Theatre Salina Expansion – Proj #22-3239

ADDENDUM NO. 4

THEATRE SALINA
DANCE STUDIOS & SCENE SHOP EXPANSION
SALINA, KANSAS

COPYRIGHT ©

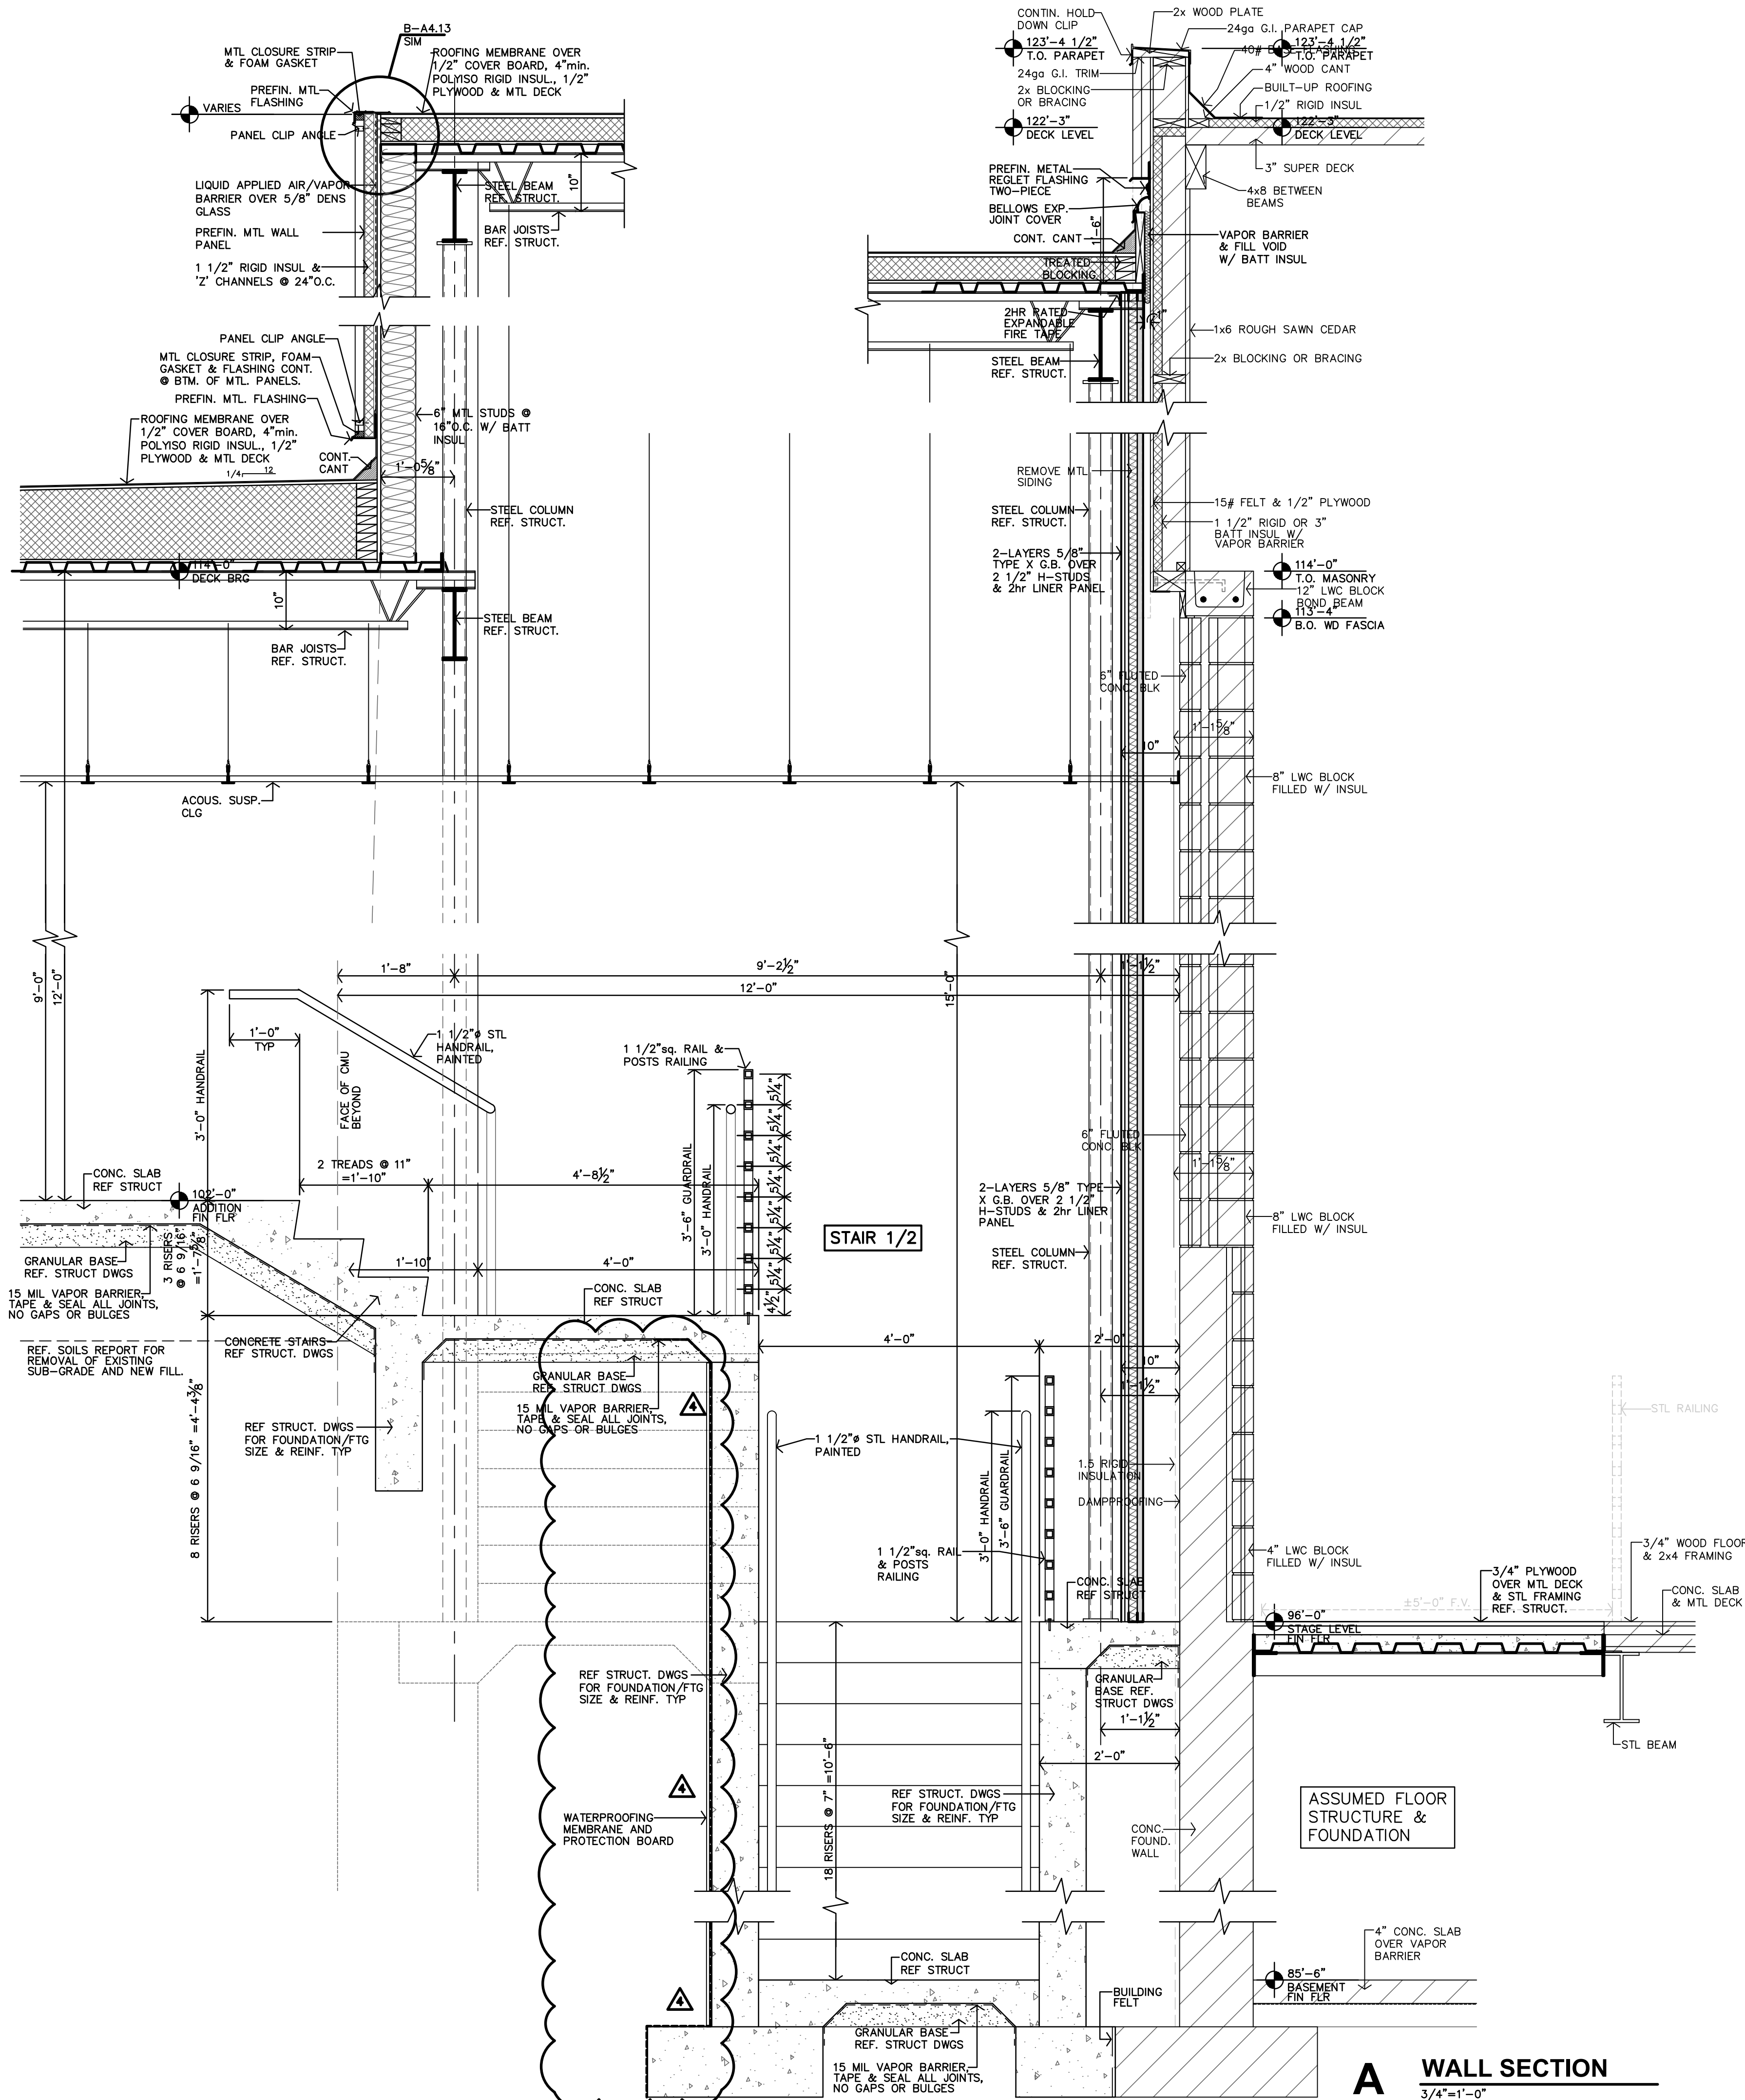
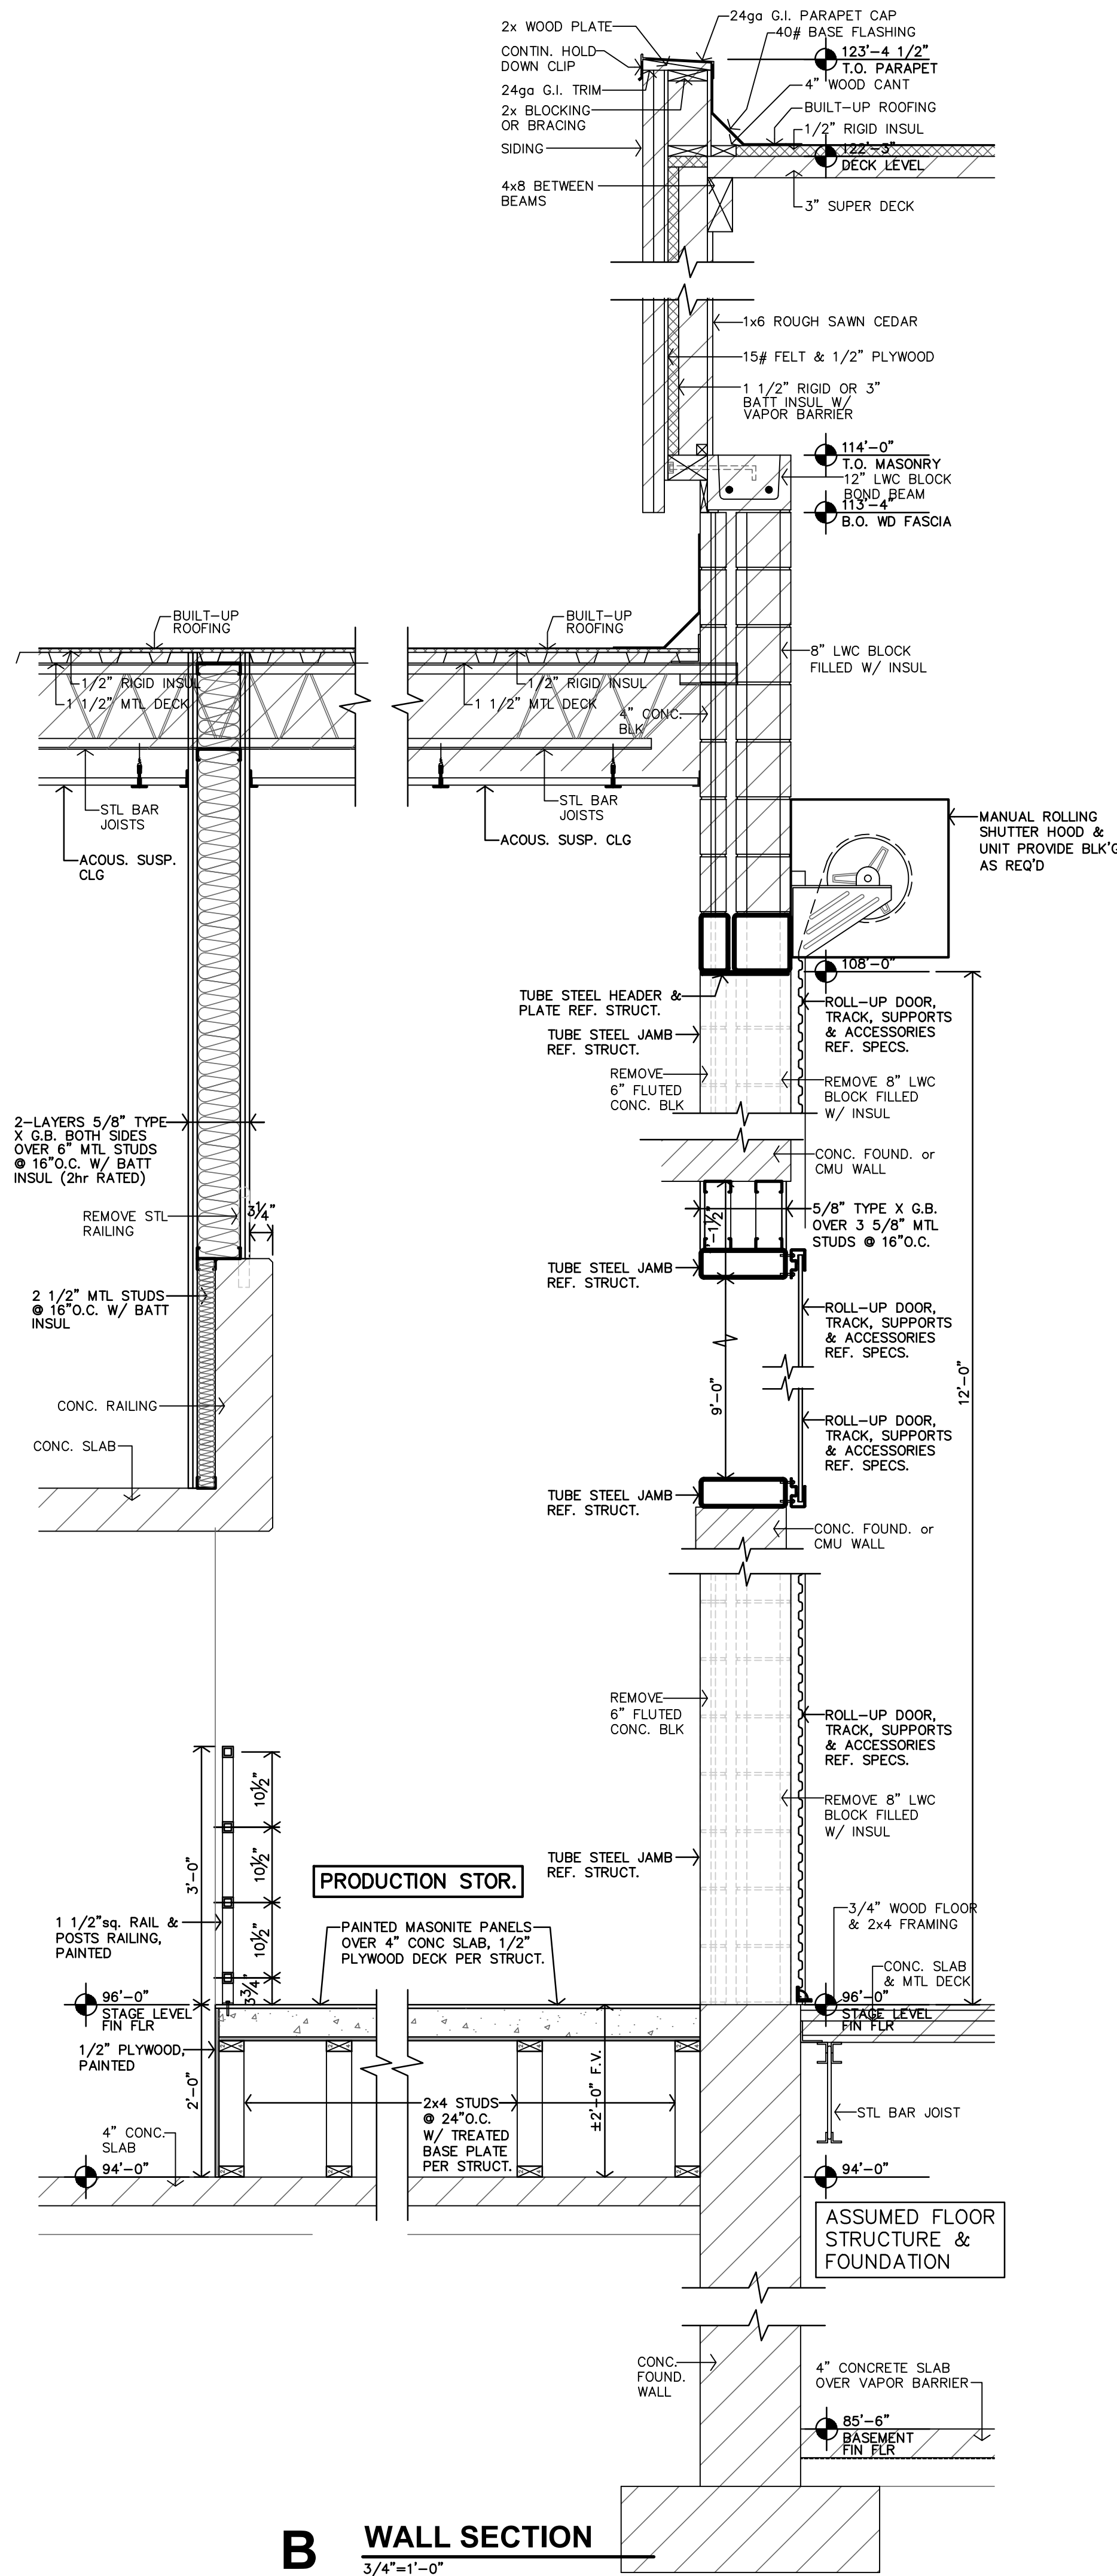
3. Sheet A4.5 and A4.6 Wall sections - Clarification, all new walls exposed to basement areas, including Stairs S1/S2 shall be waterproofed with membrane waterproofing and protection board per specifications. Reference the attached revised sheet A4.5 and A4.6.
